**Request for Additional Information No. 20, Revision 0**

**7/28/2008**

**U.S. EPR Standard Design Certification**

**SRP Section: 09.05.01 - Fire Protection Program**

Figure 9.5.1-1—Fire Water Distribution System  
Sheet 10 of 13

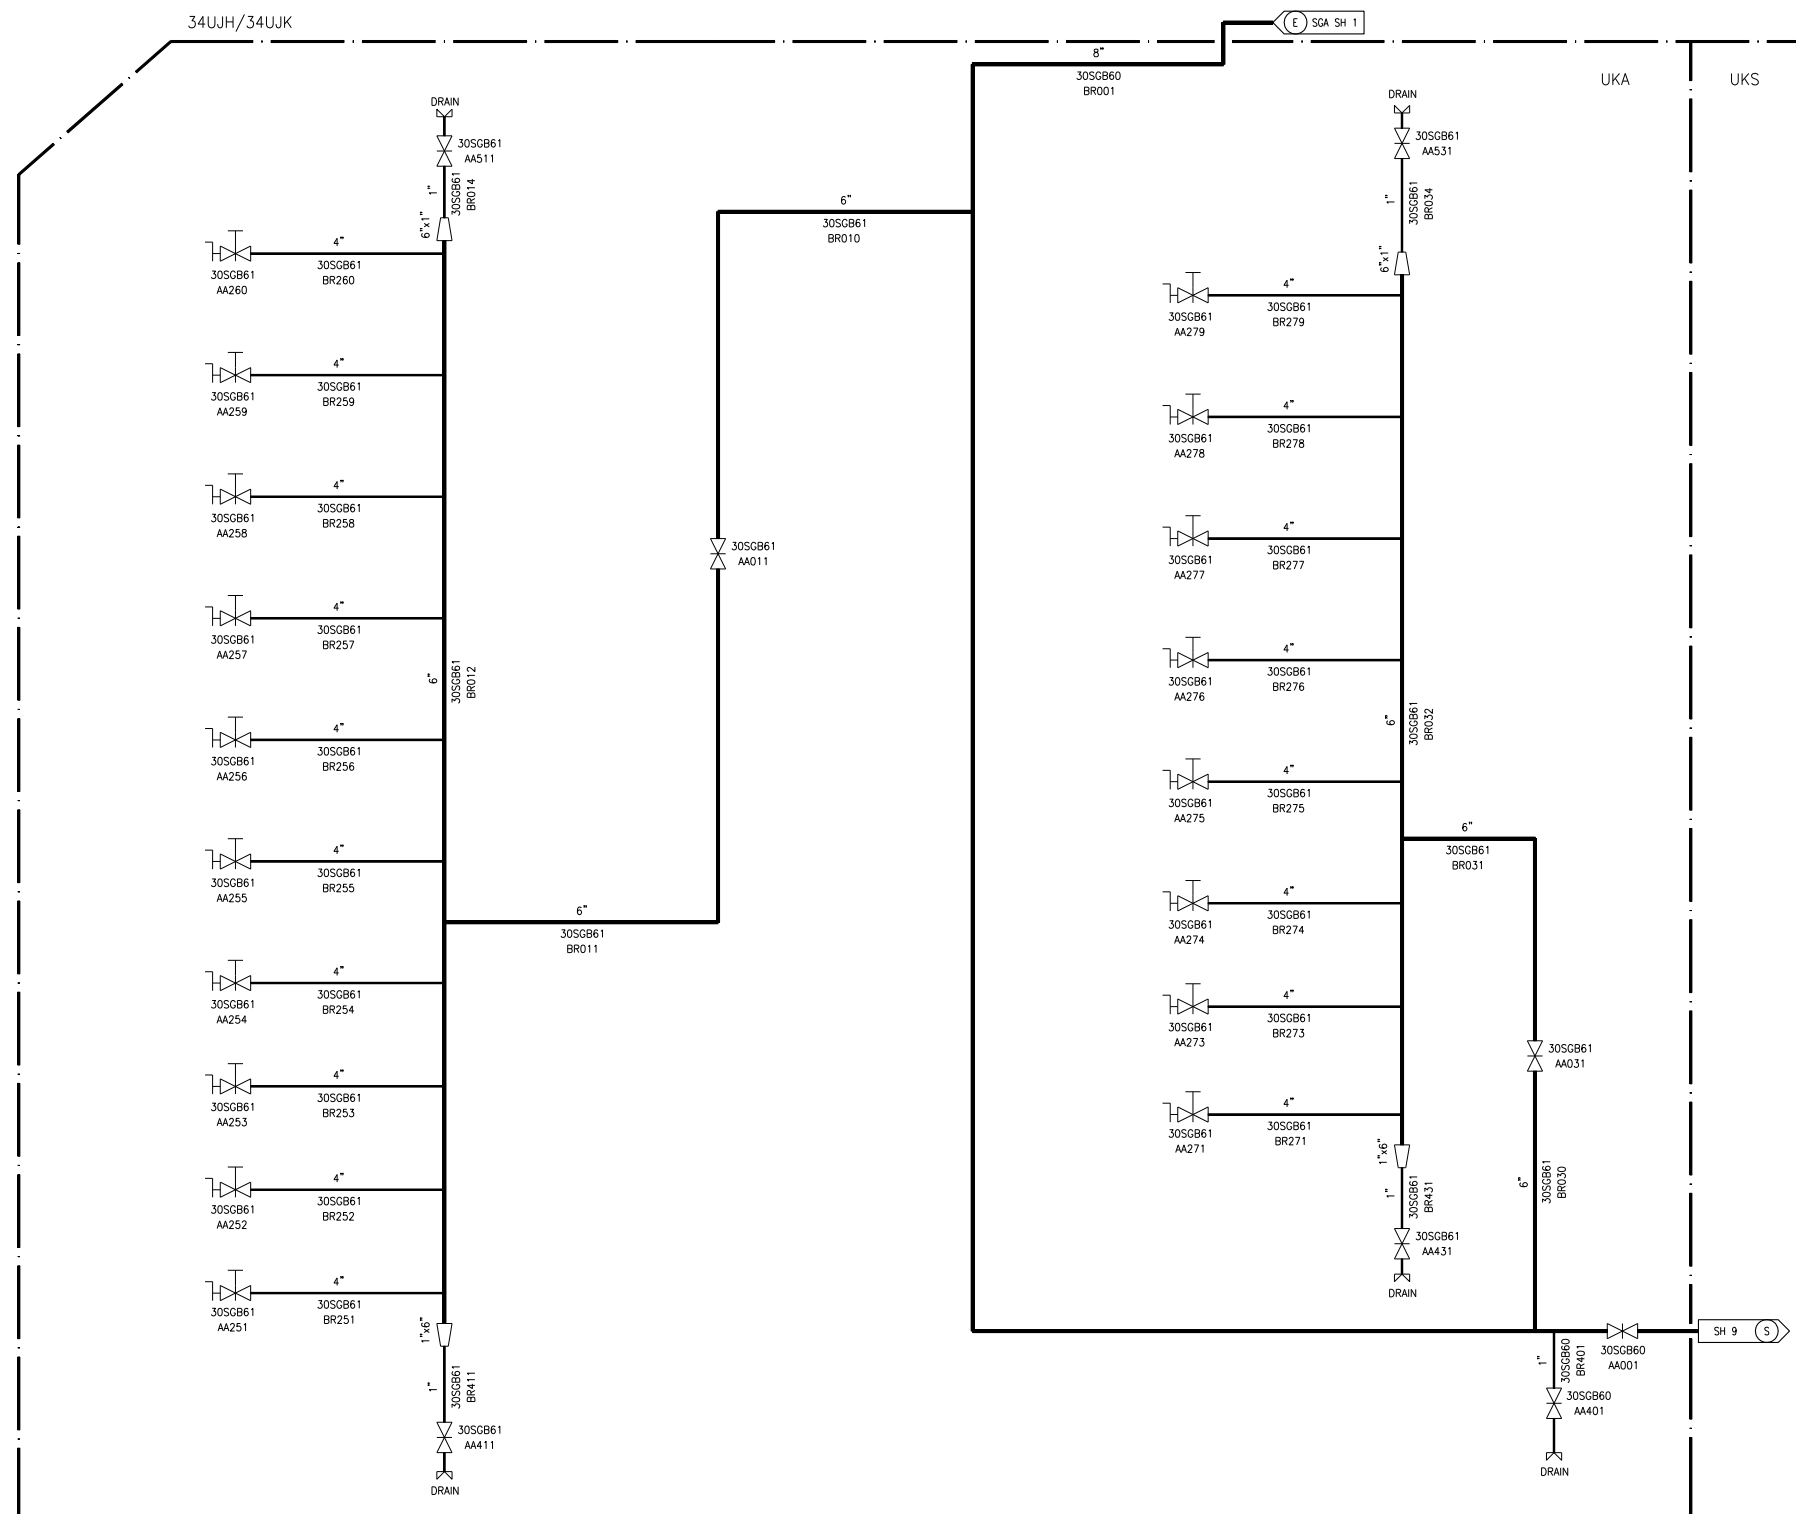
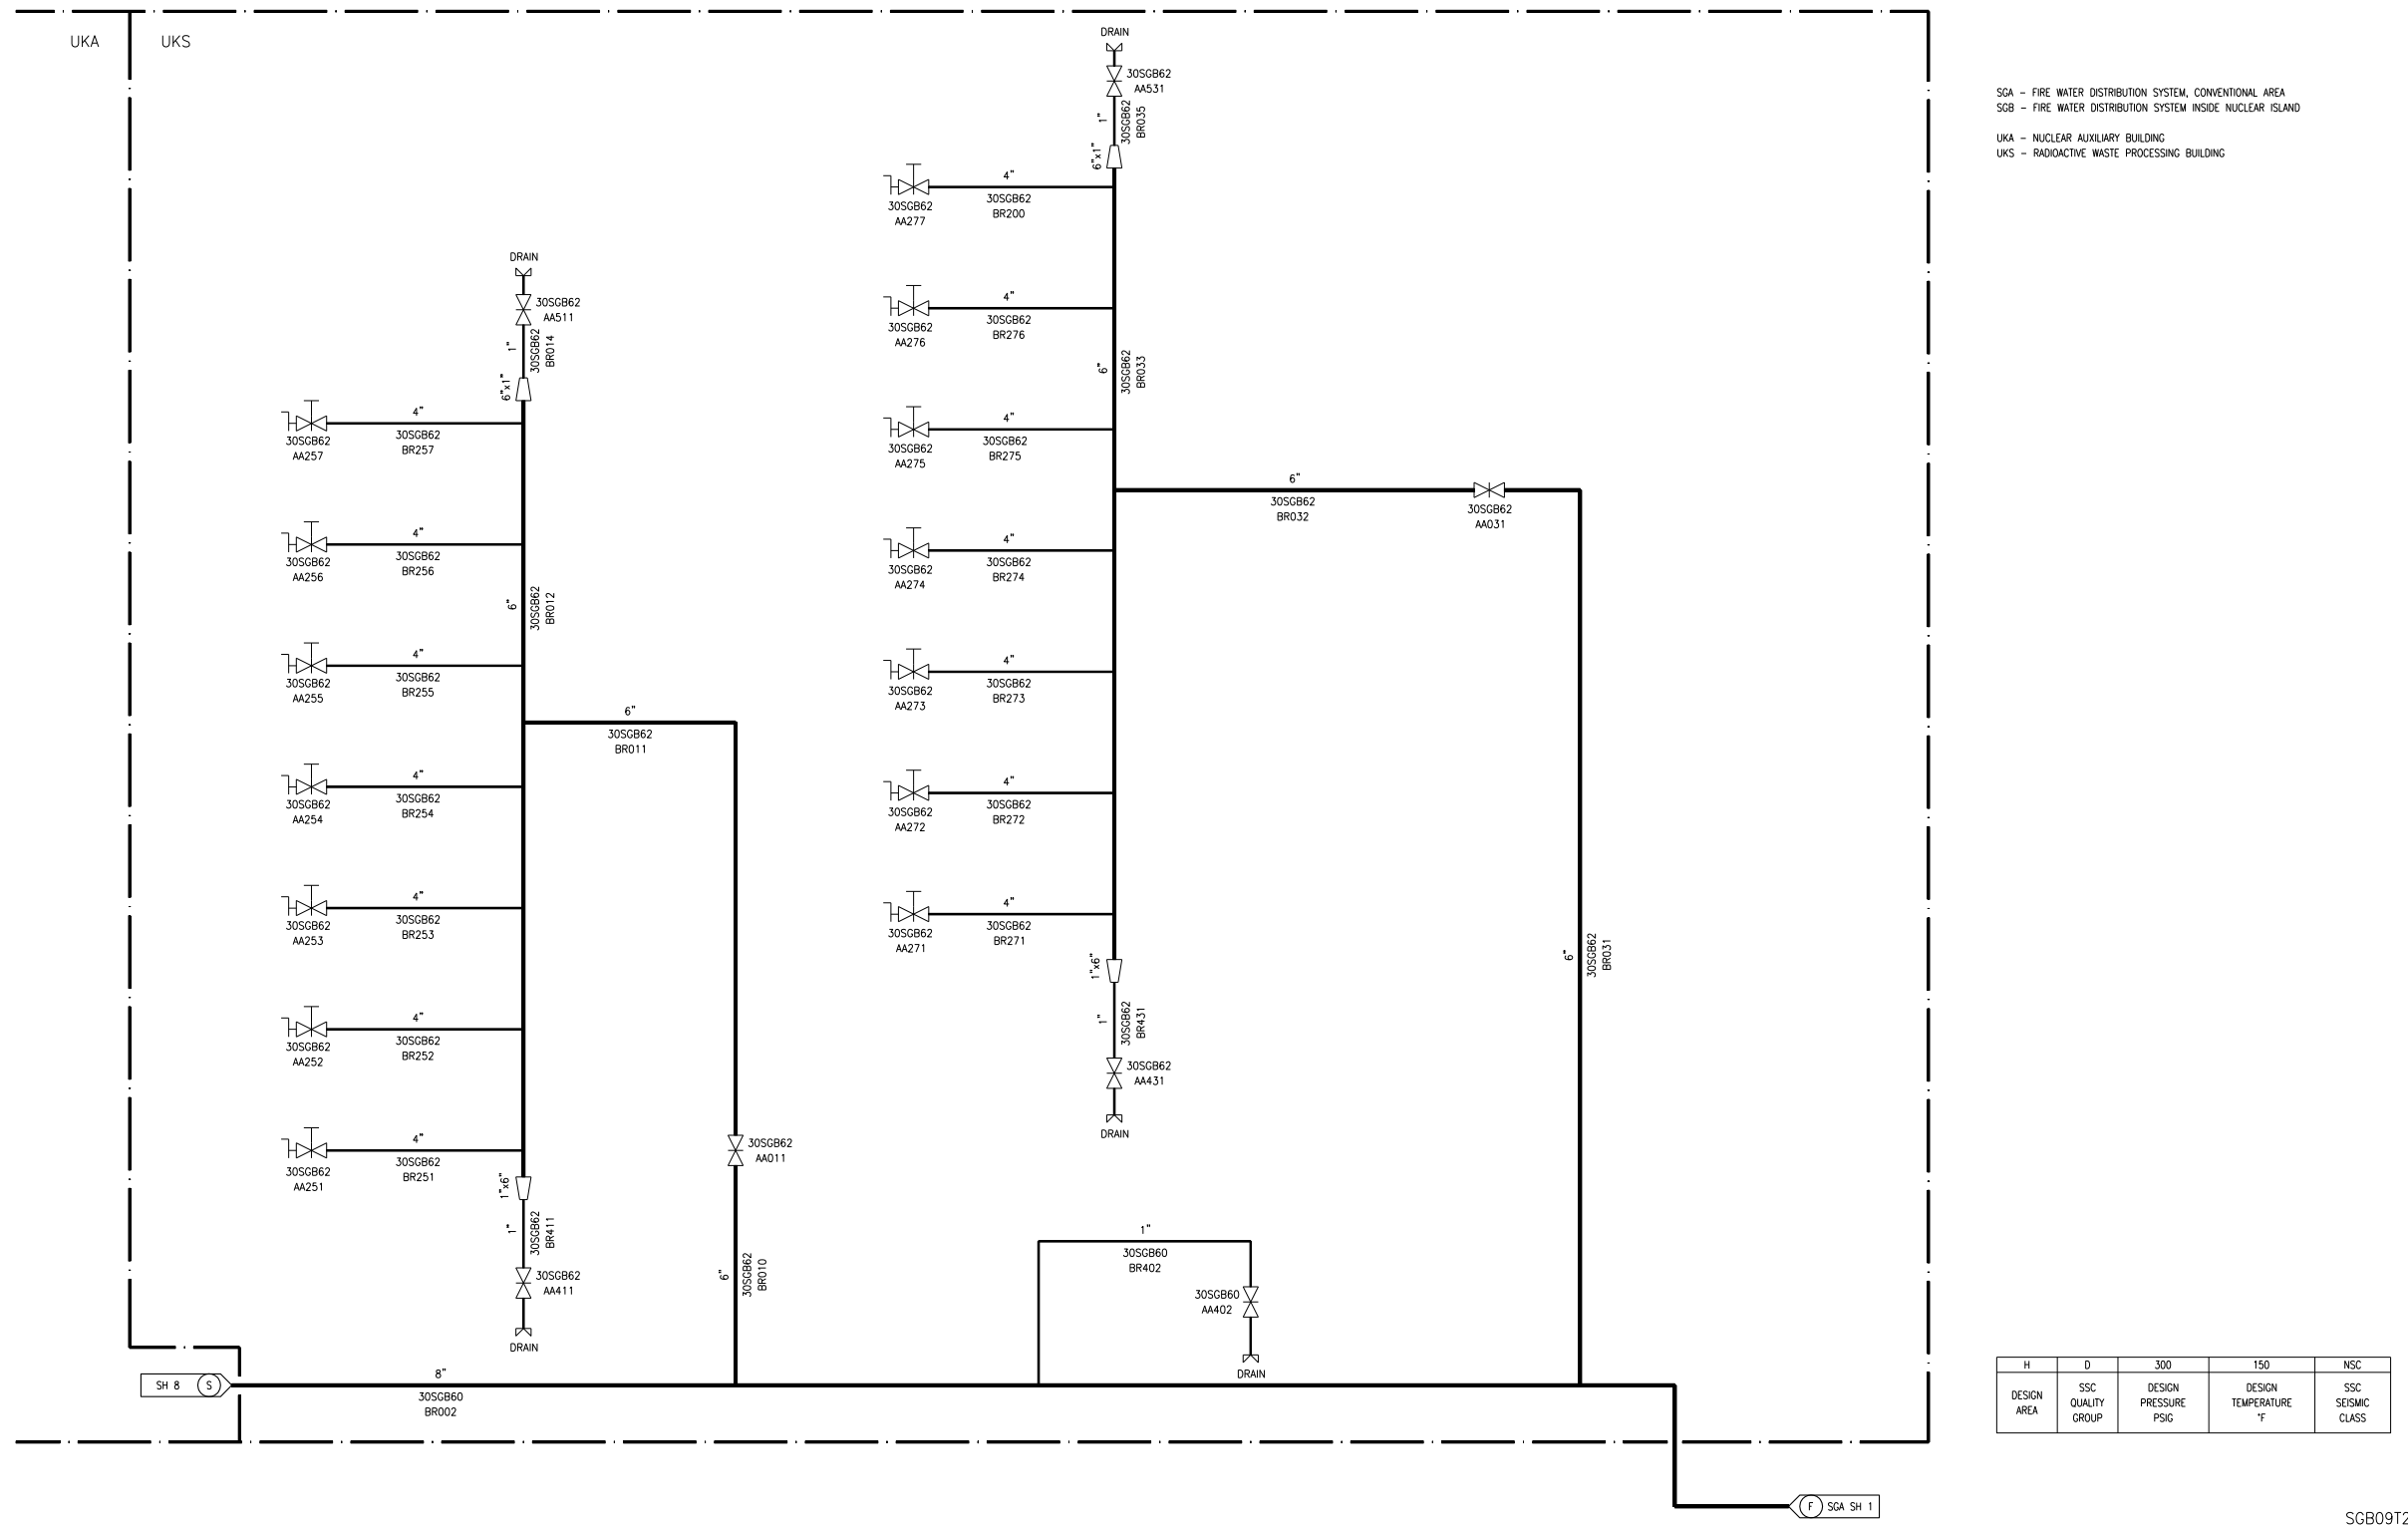
The EPR FSAR should add a COL information item to provide simplified FPS piping and instrumentation diagrams showing complete site-specific systems. Nuclear Island definition is different in Figure 9.5.1-1 then in Tier 1 Section 2.1.1. Modify FSAR accordingly. Basis: Completeness of application.

U.S. EPR FSAR Tier 2, Figure 9.5.1-1 depicts the fire water distribution system for the Nuclear Island (NI) and plant areas not considered part of the NI. However, the current title for this figure is "Fire Water Distribution System Inside Nuclear Island."

The title for U.S. EPR FSAR Tier 2, Figure 9.5.1-1 will be changed to "Fire Water Distribution System." The reference to this figure in U.S. EPR FSAR Tier 2, Section 9.5.1.2.1, under "Fire Water Supply System," will be revised to reflect the new title identified above.

U.S. EPR FSAR Tier 2, Section 9.5.1.2.1 will be revised as described in the response and indicated on the enclosed markup. U.S. EPR FSAR Tier 2, Figure 9.5.1-1 will be revised as described in the response and indicated on the enclosed markup. U.S. EPR FSAR Tier 2, Table 1.8-2 will be revised as described in the response and indicated on the enclosed markup.
